Thoughts on NEI Comments on Draft Regulatory Issue Summary (RIS) - Considerations in Licensing High Burnup Spent Fuel (HBF) in Dry Storage And Transportation

Huda Akhavannik
NMSS/DSFM/SFLB

May 18, 2015
Public Meeting with NEI

“Transportation Flowchart” cont.

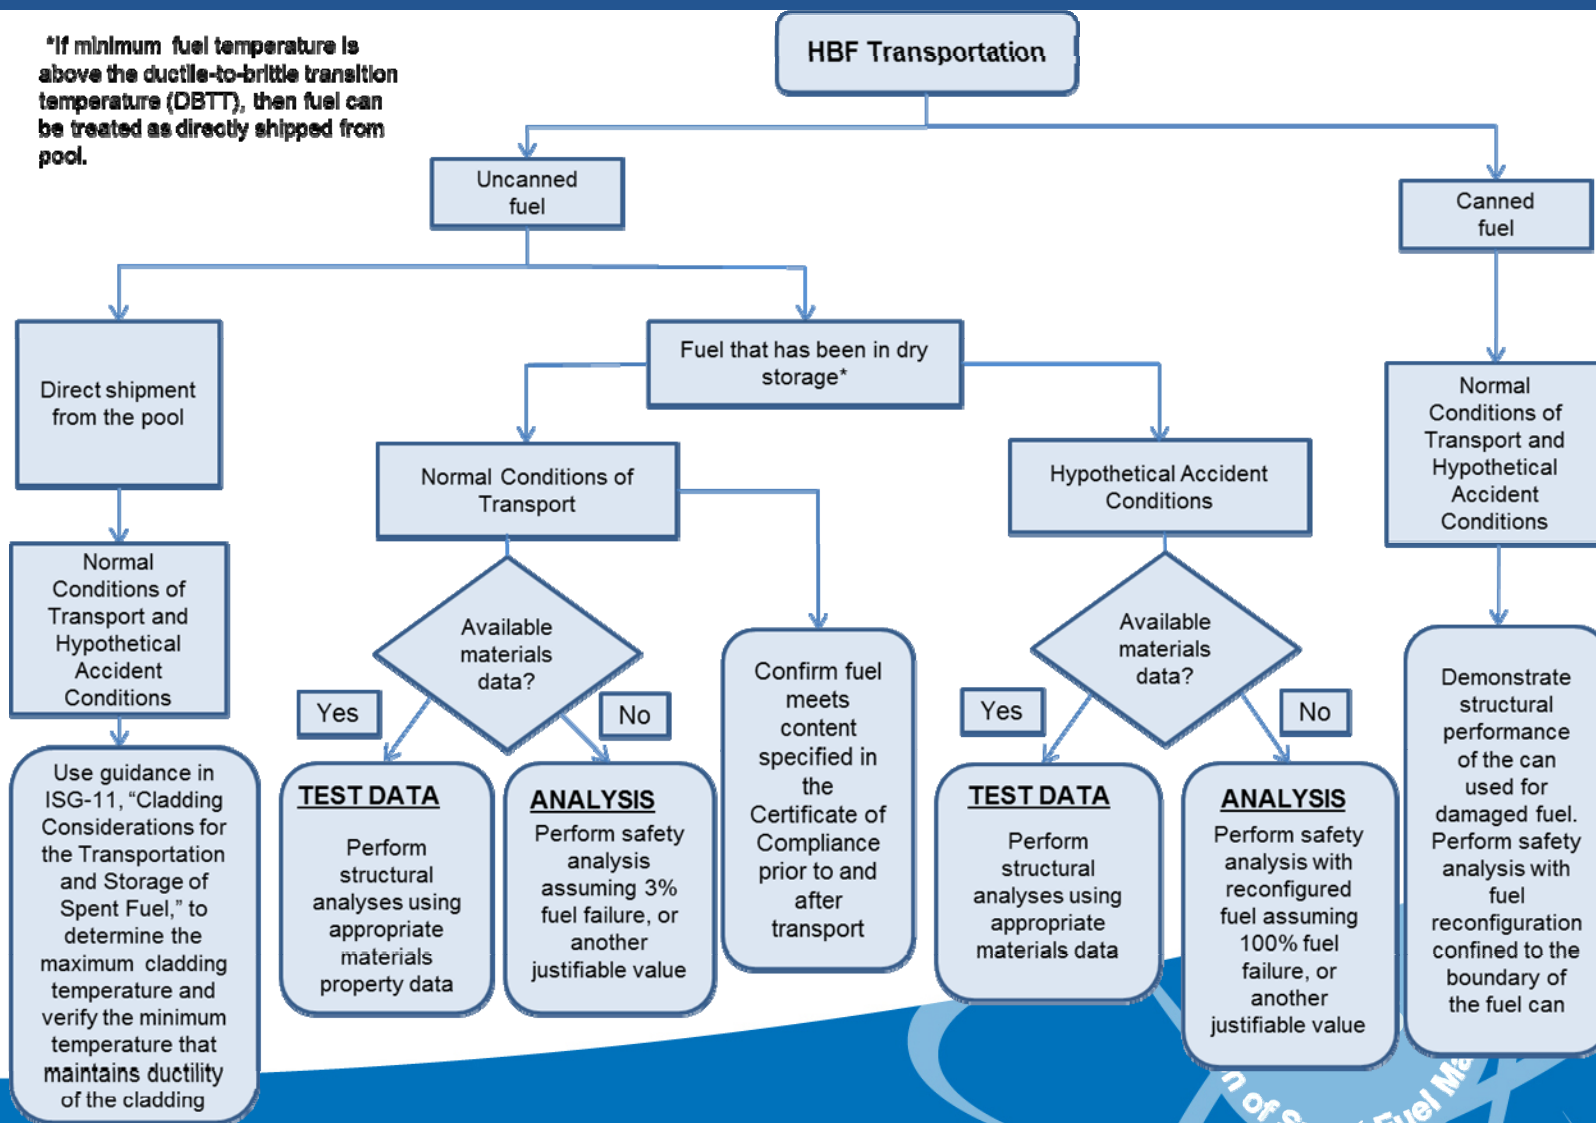
- Table Comment #2, Part 2 and Table Comment #14
- Why are different paths established for fuel directly shipped from the pool and fuel that has been in dry storage?
- This should be revised based on whether the fuel temperature is above or below the DBTT at the time of shipment
- Concept of hydride reorientation and DBTT is explicitly stated in flowchart (asterisk)
- Already have application using approach from the spent fuel pool
- Keeping statement as-is

- Concept of hydride reorientation and DBTT is explicitly stated in flowchart (asterisk)
- Already have application using approach from the spent fuel pool
- Keeping statement as-is
